FEDERAL TRADE COMMISSION

16 CFR Part 305

Energy and Water Use Labeling for Consumer Products Under the Energy Policy and Conservation Act (Energy Labeling Rule)

ACTION: Final rule.

Prototype Label 1 – Refrigerator-Freezer

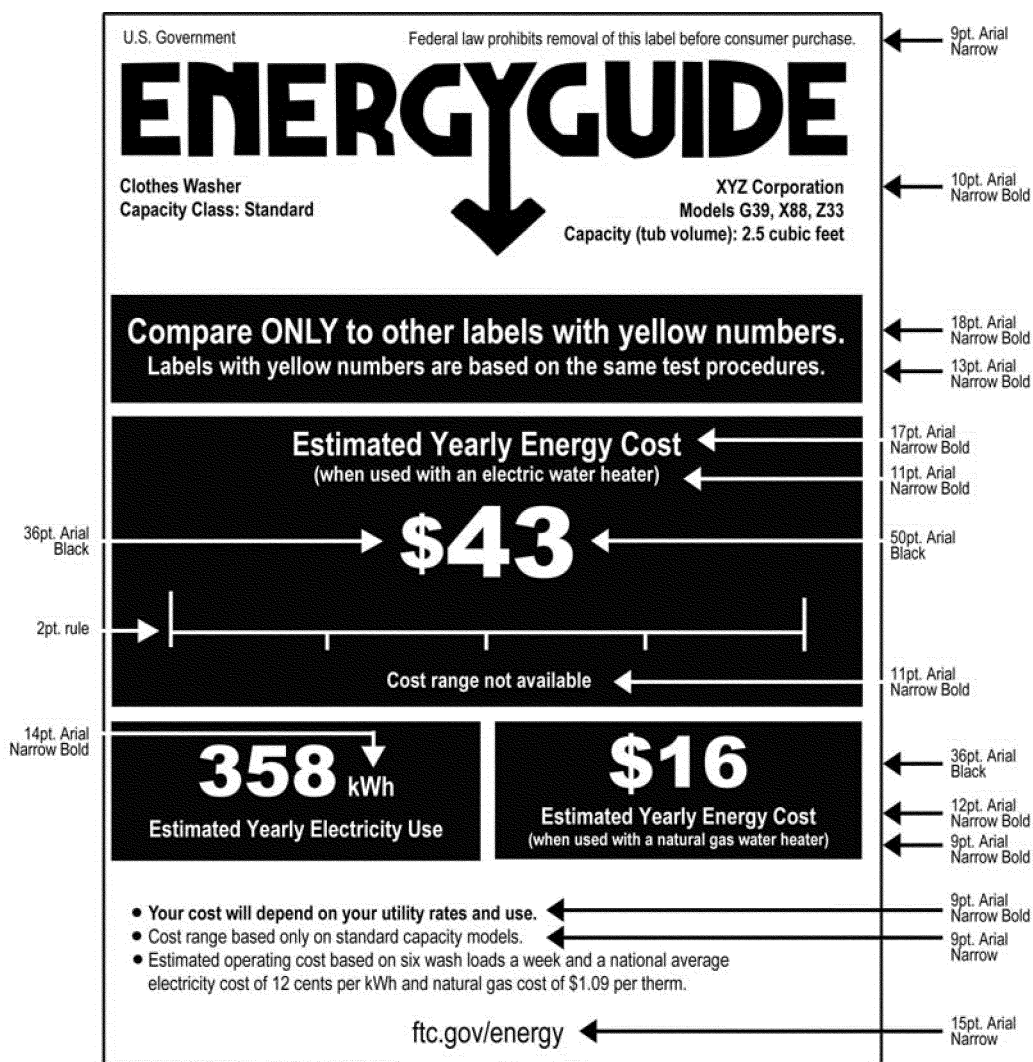
- 5. Appendix L to part 305 is amended as follows:
- a. Prototype Labels 1, 2, 3, and 4 are revised;

Sample Label 7A – Single-package Central Air Conditioner

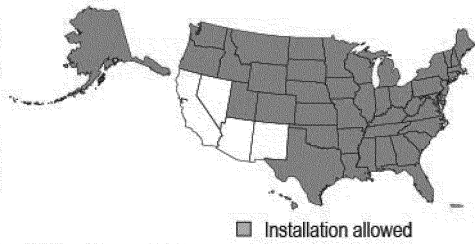
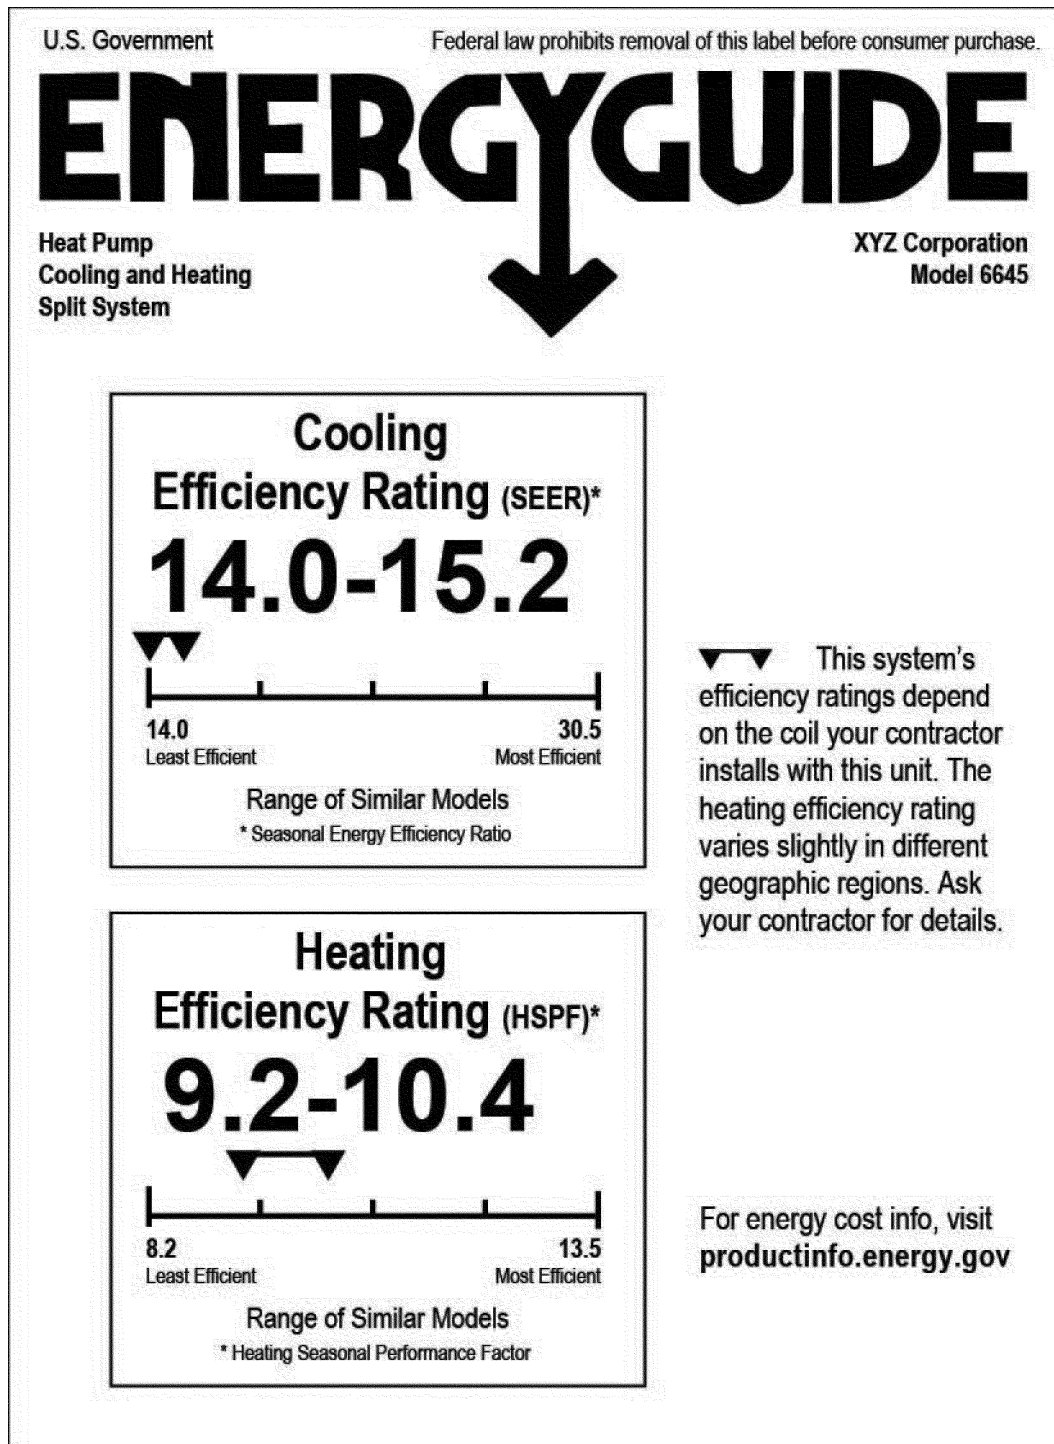
- b. Sample Labels 7, 7A, 8, 9, 9A, and 9B are revised;
- c. Sample Labels 7B and 8A are removed; and
- d. Sample Label 17 is added.

(6)(i) Each cooling-only central air conditioner label shall contain a range of comparability consisting of the lowest and highest SEER for all cooling only central air conditioners consistent with

(13) For any single-package air conditioner with an EER below 11.0, the label must contain the following regional standards information consistent with sample label 7B in appendix L to this part:

(ii) A map and accompanying text as illustrated in the sample label 7A in appendix L.

Sample Label 9 – Non-weatherized Gas Furnace

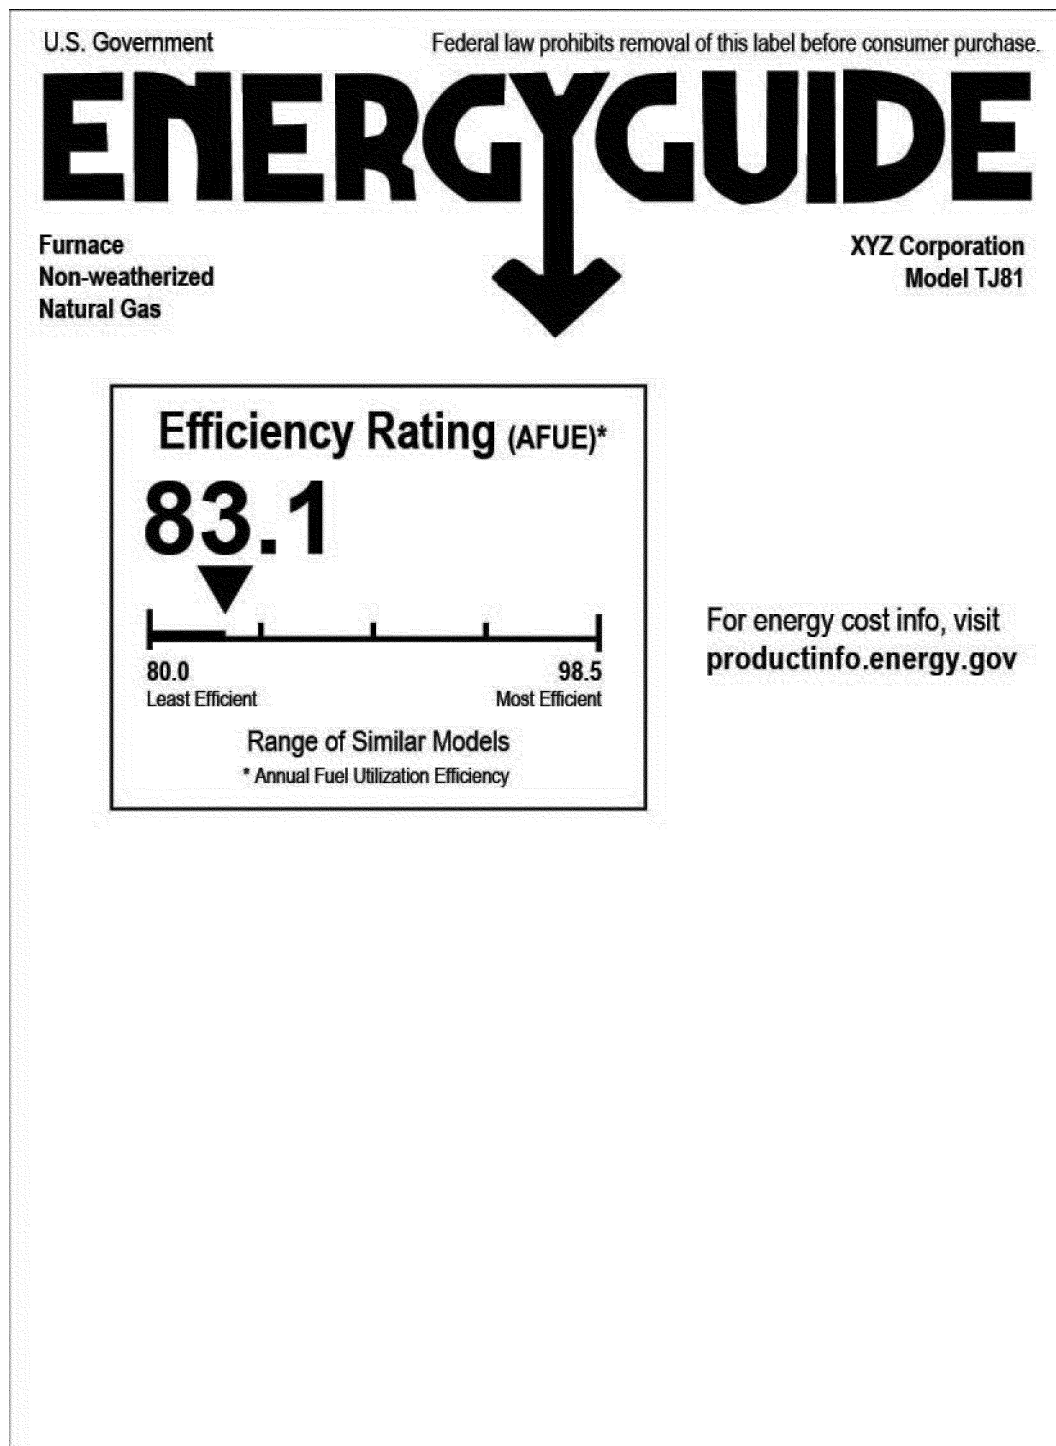
Discussion: Consistent with its proposal in the SNPRM, the Commission updates furnace and boiler labels to include new range information,²⁰ provide the link to the DOE Web site for cost information, and eliminate the capacity disclosure requirement.²¹ In the absence of regional furnace standards following the DOE Settlement, the amendments eliminate any disclosures related to regional standards for such products. If DOE issues revised regional standards in the future, the Commission will revisit whether and how to require label disclosures relating to regional standards. To ensure industry members have adequate time to implement these

(6) Ranges of comparability consisting of the lowest and highest annual fuel utilization efficiency (AFUE) ratings for all furnaces of the model's type consistent with the sample labels in appendix L.

(8) The following statement shall appear in bold print on furnace labels adjacent to the range(s) as illustrated in the sample labels in appendix L:

For energy cost info, visit
productinfo.energy.gov.
